TN-40HT LAR RAI MEETING

MAY 7TH, 2009

**NON-PROPRIETARY RAI RESPONSES AS OF
05/07/09**

Figure M19-1 UO_2 Thermal Conductivity

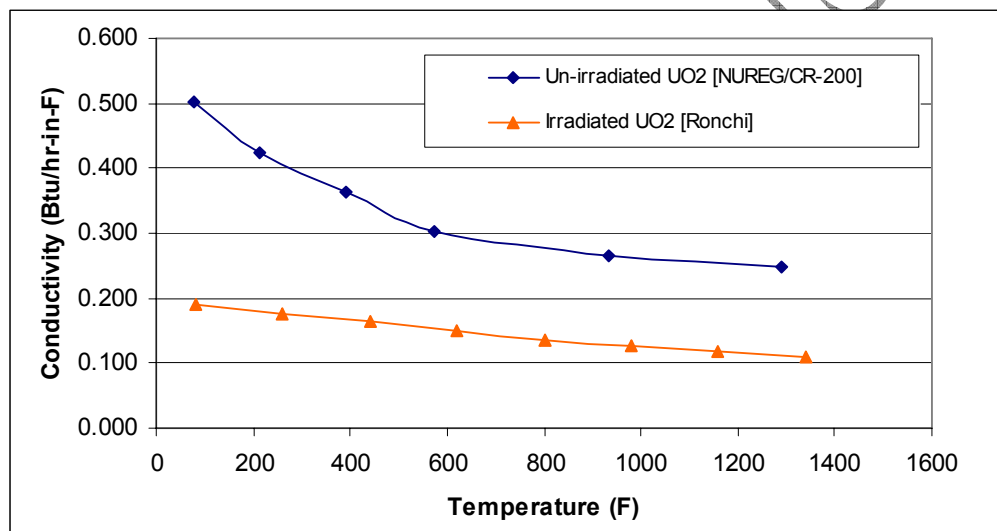
Provide thermal conductivities for fuel with a burnup of 60 GWd/MTU.

Using irradiated UO_2 conductivity decreases the effective fuel conductivity in the transverse direction. Note that as discussed in SAR Section A3.3.2.2.3.6.3.2, the axial effective fuel conductivity is calculated based on the fuel cladding material only and does not include the UO_2 fuel pellet thermal conductivity. Therefore, the axial effective conductivity of the fuel assembly is not impacted.

The thermal conductivity values of UO_2 in SAR Section A3.3.2.2.3.6.2.1 for un-irradiated pellets are compared to the values obtained from the study by Ronchi et al. [2] and are shown in the Figure M19-1. For the temperature range of interest, the comparison shows that the SAR conductivity values are higher by approximately a factor of two compared to the values obtained from Ronchi et al. [2].

A study performed by Transnuclear (TN) and provided to the NRC via an RAI response to NUHOMS[®] HD System, Amendment 1 [3] shows that the transverse effective fuel conductivity with irradiated UO_2 conductivity is approximately 3% lower than the one with un-irradiated UO_2 conductivity at the operating temperature of 700°F.

The sensitivity runs in the TN study show that the fuel cladding temperature changes by approximately 1°F due to use of irradiated UO_2 conductivity. A 1°F temperature change is considered to be negligible. These results show that the fuel cladding temperatures are not sensitive to the conductivity of UO_2 .

Figure A4.3-2 Bottom Shield Plate, Cross Section Locations

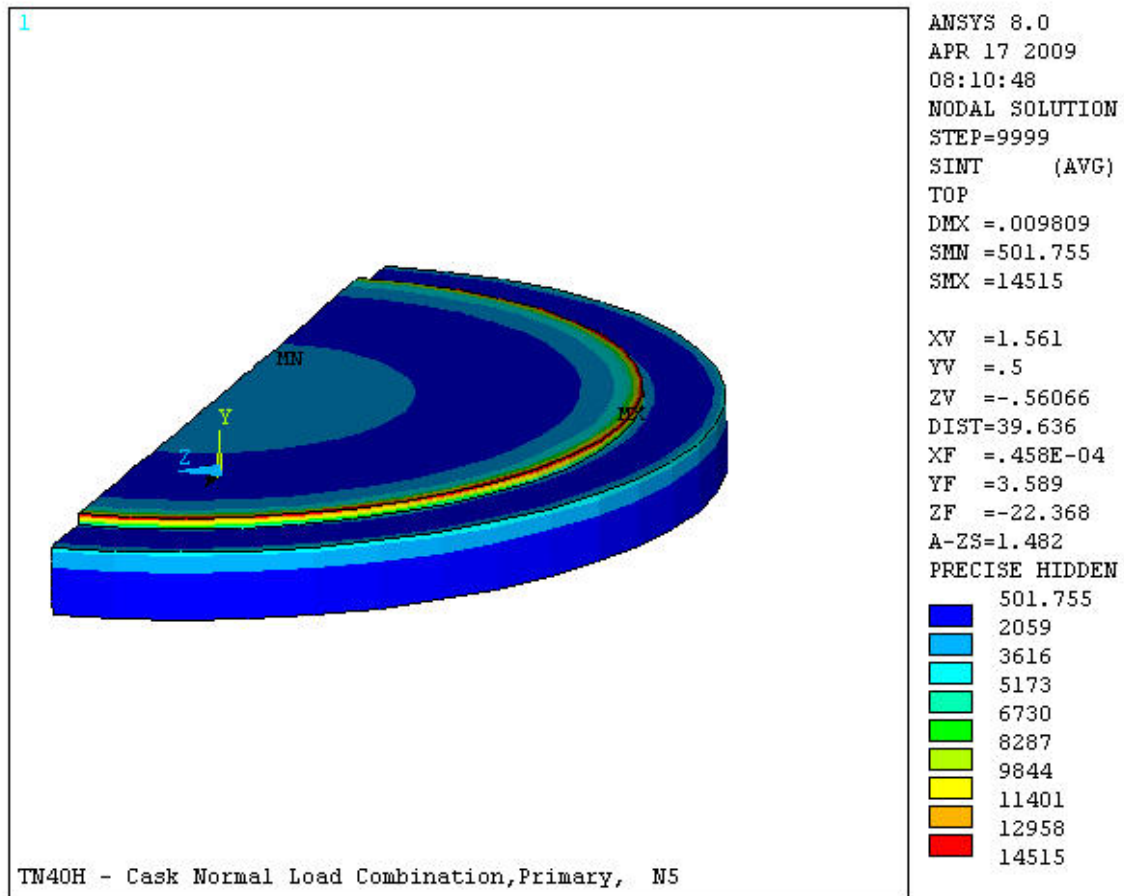
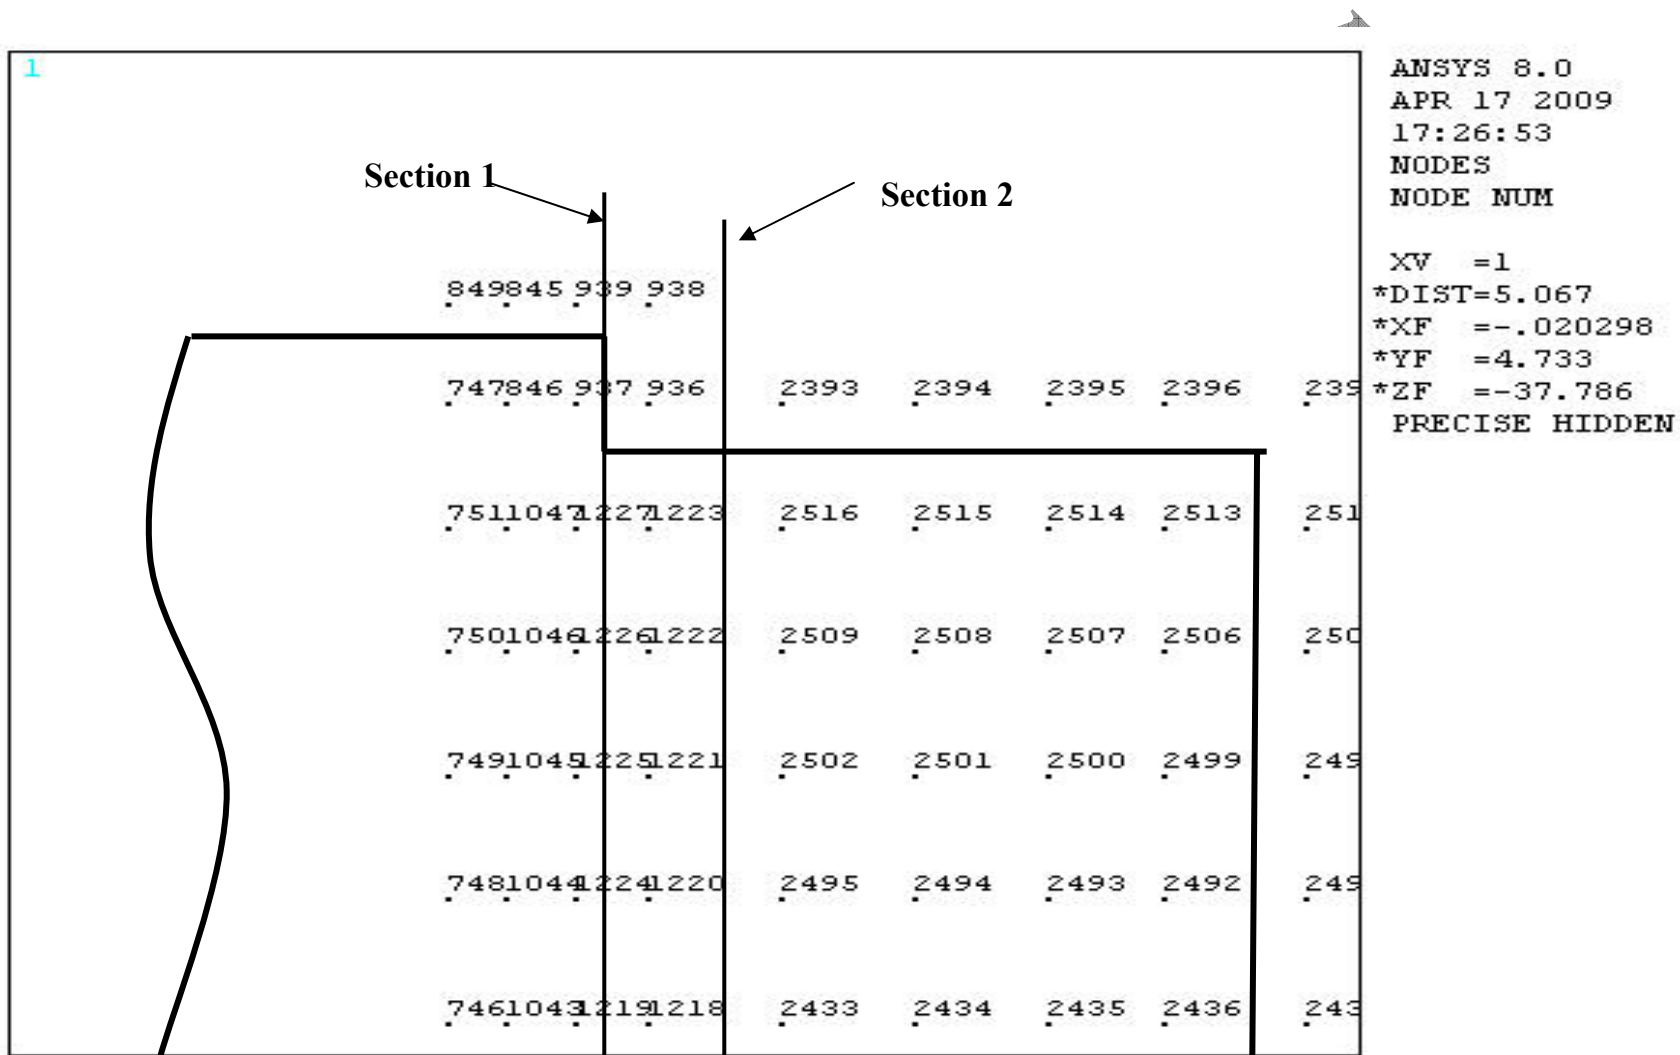
With respect to load combination Case N5, use nodal stress intensities at Nodes 938 and 1218 and any intervening nodes, as appropriate, in an explicit calculation to verify that the stress linearization post-processing is properly implemented for calculating the primary membrane, Pm, and primary membrane-plus-bending, PI + Pb, stress intensities.

With respect to load combination Case N5, the process of nodal stress components combination at Nodes 938 and 1218 and intervening Nodes 936, 1223, 1222, 1221 & 1220 (see Figure A4.3-2, cross section 1) and stress intensity computations are properly implemented by ANSYS postprocessor by following the procedure given in ASME Boiler and Pressure Vessel Code, Section III,

Subsection NB, Para NB-3215. According to ANSYS postprocessor procedure, stress components S_x , S_y and S_z for normal stresses and S_{xy} , S_{yz} and S_{zx} for shear stresses (in global or prescribed coordinate system) of individual loads are algebraically combined for the load combination case at all the nodes defining the cross section. Each combined stress component is then linearized to get membrane, bending, membrane plus bending and peak stress categories at the beginning, mid-length and the end of the cross section. Principal stresses S_1 , S_2 and S_3 are computed using the membrane, bending, membrane plus bending and peak component stresses. Stress differences S_{12} , S_{23} and S_{31} are calculated using these principal stresses and stress intensity S is the largest absolute value of S_{12} , S_{23} and S_{31} for membrane, membrane plus bending and peak stresses.

The listed primary stress intensities P_m and $P_i + P_b$ of 1.98 ksi and 5.67 ksi, respectively, at the cross section defined by Nodes 938 and 1218, are much smaller than the maximum nodal stress intensity of 14.52 ksi at Node 938. The reason being that a high stress intensity of 14.52 ksi occurs locally at the corner of the Bottom Shield Plate (see Figure A4.3-1) where the gamma cylinder is contacting. In the remaining large portion of the cross section, stresses are small. The stress linearizing details at this cross section (Figure A4.3-2, cross section 1), using the ANSYS processor, are given in Table A4.3-1. It can be seen that although membrane and membrane plus bending stress intensities are small at top (Node 938) and bottom (Node 1218) of the cross section, a high peak stress intensity of 9.90 ksi occurs at the cross section top and the sum of the membrane plus bending and peak stress intensities is quite close to the maximum nodal stress intensity. This shows that the ANSYS stress linearization post-processing is quite proper.

For further verification, an adjoining cross section defined by Nodes 2393 and 2433 (and intervening nodes) is selected for linearizing (see Figure A4.3-2, cross section 2). The maximum nodal stress intensity at this section is 2.42 ksi. Local stresses at this cross section are expected to be negligible. The linearized stress intensities at this cross section are listed in Table A4.3-2. It is seen that the maximum membrane plus bending and peak stress intensities are calculated as 2.16 ksi and 0.68 ksi respectively and the sum of membrane plus bending and peak stress intensities is quite close to the maximum nodal stress intensity.

FIGURE A4B.1-21
BOUNDARY CONDITIONS AND INTERFACES FOR TYPICAL FUEL
COMPARTMENT TUBE

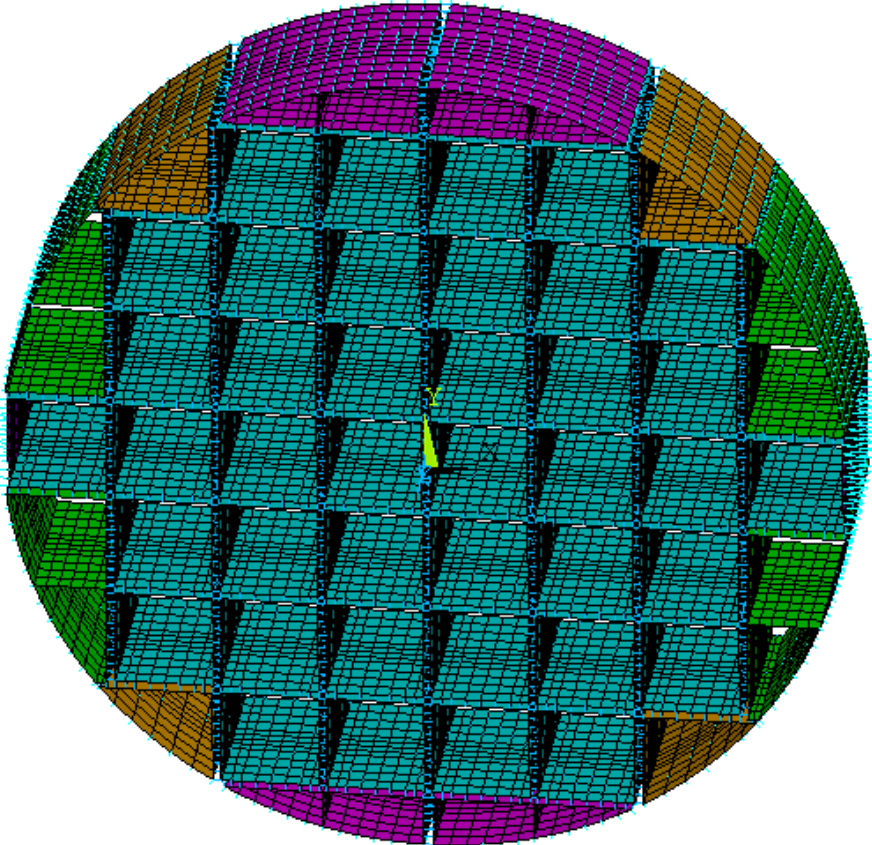
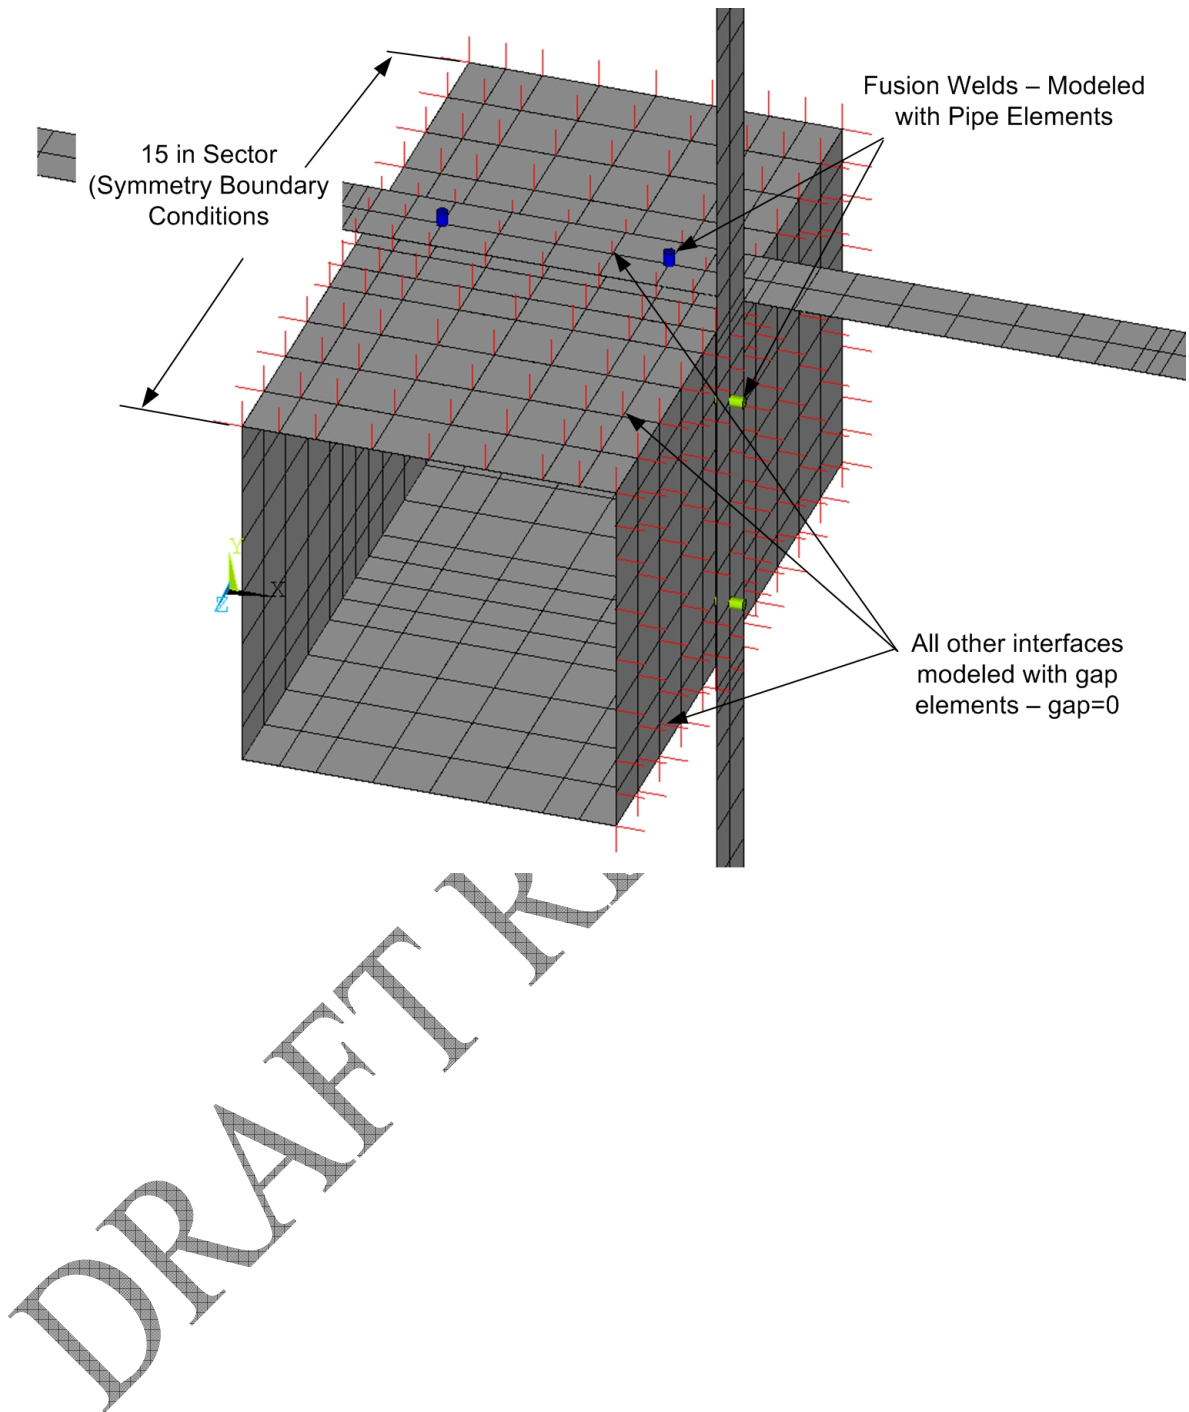
Revise Figures A4B.1-2, A4B.1-3 and add additional sketches to provide sufficiently legible details to depict element types, discretization schemes, and interface as well as boundary conditions, as appropriate, for the structural analysis of the basket subject to lateral loads.

The fuel compartment tubes, support plates, and transition rails are modeled with shell elements. The fusion welds that connect the fuel compartments and plates are modeled utilizing pipe elements connected at each end to adjacent fuel compartment boxes. All other interfaces (i.e., between fuel compartments, between fuel compartments and support plates, between fuel compartments and transition rails, and between transition rails and the cask) are modeled by gap elements. For all interfaces through aluminum and poison plates, the plates are

assumed to be in contact to simulate support provided by the aluminum and poison plates.

The title of Figure A4B.1-2 will be modified to clarify that it shows the loading orientations only. Figure A4B.1-3 will be modified to the new figure shown below. Figure A4B.1-21 below will be added to clearly depict the element types, discretization schemes, interface, and boundary conditions. In addition to modifying the figures, the text in Section A4B1.5 will be modified to reflect the appropriate figure numbers and the last sentence in the third paragraph in Section A4B1.5.2.1 will be replaced with the following:
